Technical Memo

To:	Onur Oktem – FTAA Programme Manager QLDC
From:	Corinne Frischknecht, Senior Policy Planner, Planning and Development
Date:	Friday, 19 June 2026
Subject:	Fast-Track Approvals Act 2024 –Mt Iron Junction Housing Scheme: Substantive Application (FTSA2601-1173) Technical Memorandum – Urban Design

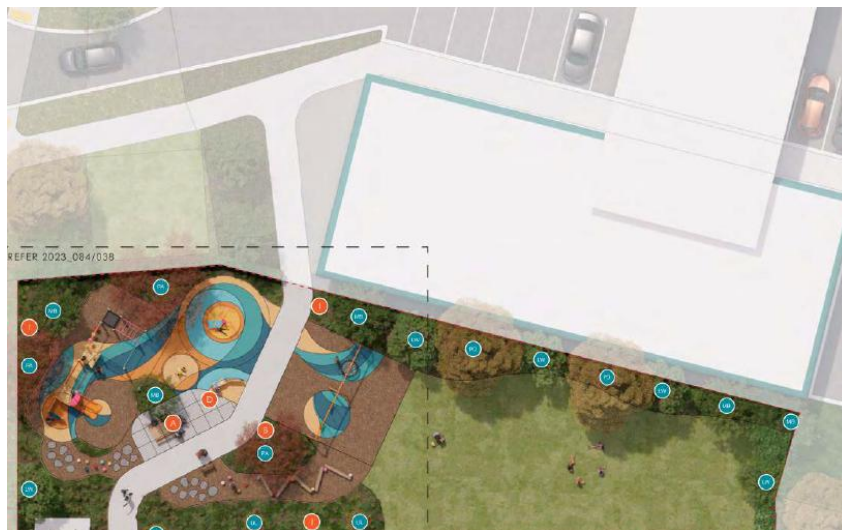
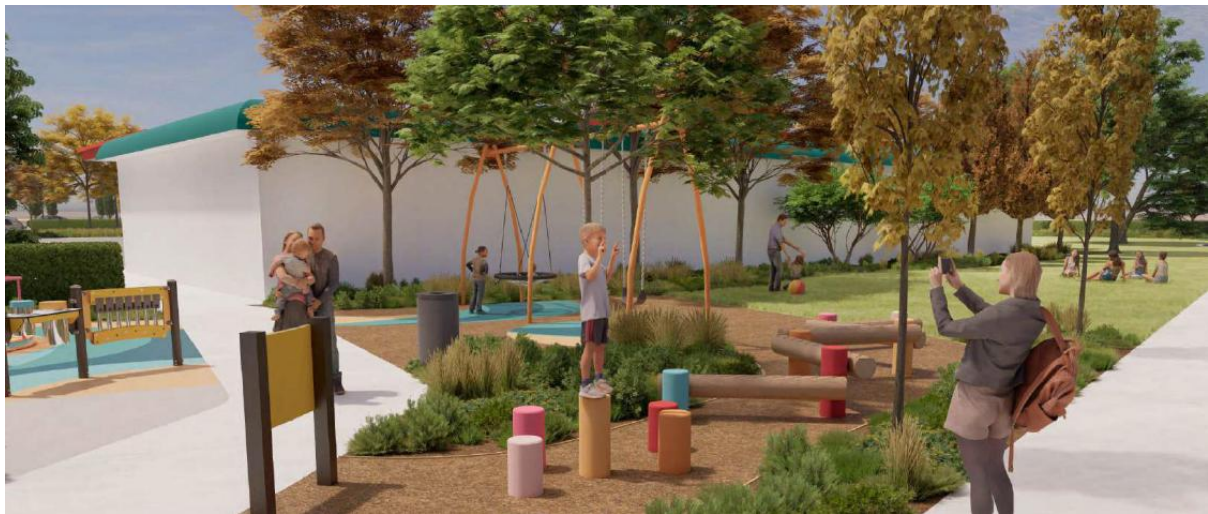
- 6.26. There does not appear to be an external all-weather (sealed) Active Travel shared path connection to Wānaka to provide a true connection with the town as well as Three Parks. This becomes extremely important in providing future residents with greater choice regarding how they move particularly given the absence of public transportation available in this area. For these reasons, I do not agree with the Urban Design assessment that *"the proposed development is well connected and promotes a high-level of connectivity to, from and within the site, as well as in the context of the wider Wanaka region."*

- 6.27. This has also been raised in the technical advice provided by Stantec and also by Robert Galvin, Property & Infrastructure Team at QLDC, which state that to make cycling more attractive as a transport mode, it is recommended that a shared path network be provided through the whole site, as well as a continuous connection to the existing Active Travel network near the underpass at Three Parks and a new all-weather (sealed) Active Travel shared path link from the site to Aubrey Road to provide a true connection with the town.

7. Provide a new all-weather (sealed) Active Travel shared path link from the site to Aubrey Road to provide a true connection with Wānaka town (consistent with the comments provided by Stantec and QLDC Property & Infrastructure Team).
